LOCATION Hwy 401 at Guelph line
underpass (Storm Sewer)

SUBJECT: STORM SEWER AT GUELPH LINE O'PASS
HWY. #401, DISTRICT 4, SITE 30-43
CONTRACT 93-07

Re: Storm Sewer at Guelph Line Underpass
Contract 93-07; Site 30-43
Highway 401, District 4, Burlington

MEDIAN SEWER DETAIL
AT GUELPH LINE STRUCTURE

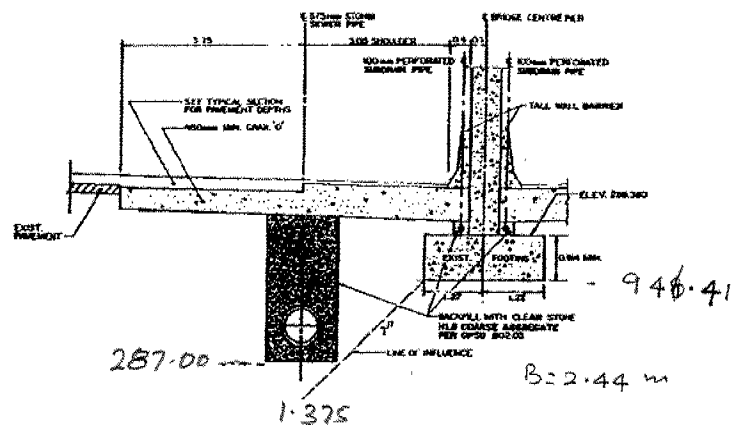
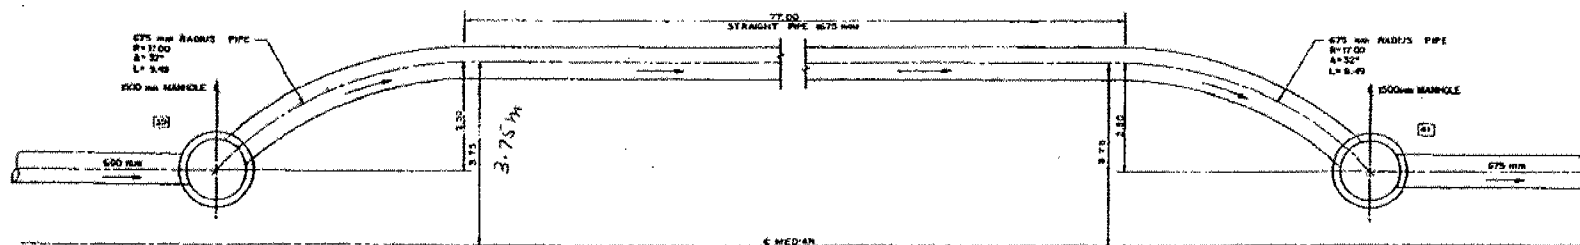
ALTERNATIVE #1 NOT RECOMMENDED; MOVEMENT OF THE FOOTING
WILL BE SUBSTANTIAL

ALTERNATIVE #2 THE INDICATED SUPPORTING SYSTEM WILL NOT
PROVIDE 'AT REST' CONDITION.
ANY MOVEMENT OF THE FOUNDING SOIL WILL
CAUSE DAMAGE TO THE FOOTING.

COMMENTS a.) THE EDGE OF ANY EXCAVATION SHOULD NOT BE
CLOSER THAN 8m.

- 1) The information provided to us indicate that the existing pier footing is placed at El: 288.5 and the excavation for the storm sewer is expected to extend below El: 287.0 (ie. 1.5 m below the footing level). In addition, the clear distance between the edge of the footing and the proposed sewer line is only 1.8 m.

- 3) Considering the subsoil condition, depth of excavation below the footing and the close proximity of the pipe location, an open trench excavation is not recommended. However, if no dewatering is involved and the footing can be supported effectively to ensure the integrity of the existing footing, the proposed scheme may be executed.

- 4) In order to avoid construction difficulties and damage to the existing footing, slurry-type micro-tunnelling equipment may be used within the close proximity of the bridge. This scheme is not feasible if any carrier pipe is considered for the sewer line.
